ALERT SERVICE BULLETIN

SUBJECT: LIMITATIONS - Control rod double bearing

Tail Gearbox (TGB)

Revision No.	Date of issue
Revision 0	2016-05-04
Revision 1	2016-06-03
Revision 2	2016-10-28
Revision 3	2017-07-20

Figure 1

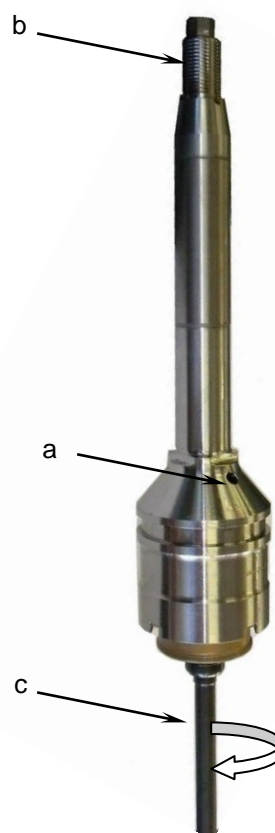
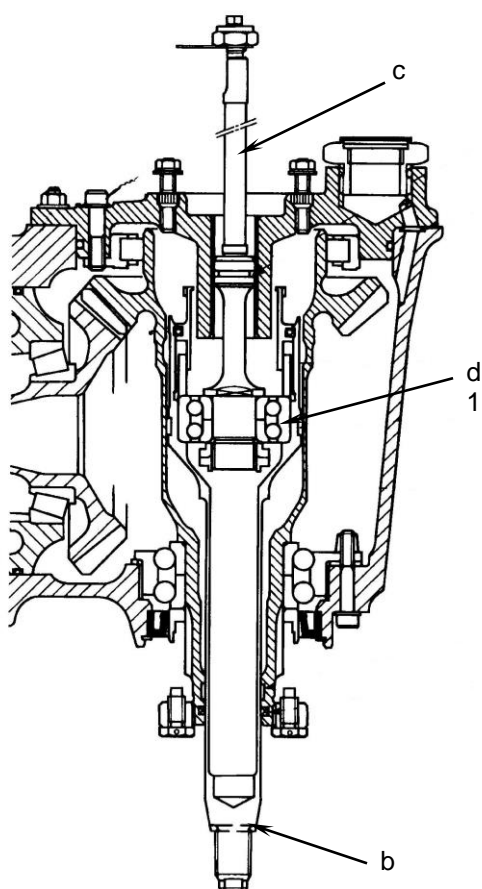
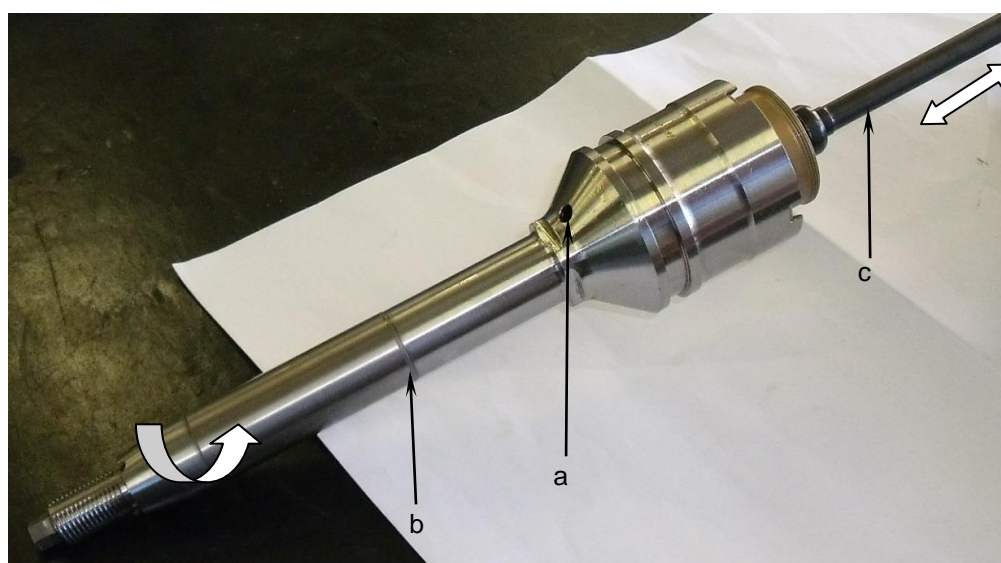
- Remove the control shaft/rod assembly as per paragraph 3.B.4.a.
- Carry out a tactile check to ensure that there is no axial play in double bearing (d) (Figure 1):
 - . Apply an alternating manual axial load to control rod (c) whilst turning control shaft (b) (**See DETAIL A Figure 1**).

- Clean the control shaft/rod assembly using WHITE SPIRIT (2) as per MTC Work Card 20.04.01.102:
 - . Inject WHITE SPIRIT (2) under pressure (for example using a can) into hole (a) of control shaft (b). (**See Detail B Figure 1**).
 - . Hold shaft (b) in the vertical position pointing upwards.
 - . Manually turn control rod (c) several times to rinse double bearing (d) by draining the WHITE SPIRIT (2) through the bearing. (**See Detail B Figure 1**).
 - . Collect the WHITE SPIRIT (2) on absorbent paper (e.g.: blotting paper):
 - Pass a magnet over the absorbent paper to collect the magnetic particles.

- . Replace double bearing (d) with a double bearing (1) as per AMM Task 65-20-01-961.
- . Install the control shaft/rod assembly as per paragraph 3.B.4.b.
- . **Inform the Airbus Helicopters Customer Service Technical Support Department in accordance with paragraph 2.B.**
- . **Comply with paragraph 2.D.**

- Replace double bearing (d) (Figure 1) with a double bearing (1) as per AMM Task 65-20-01-961.
- Install the control shaft/rod assembly as per paragraph 3.B.4.b.:
 - . **Inform the Airbus Helicopters Customer Service Technical Support Department in accordance with paragraph 2.B.**
 - . **Comply with paragraph 2.D.**
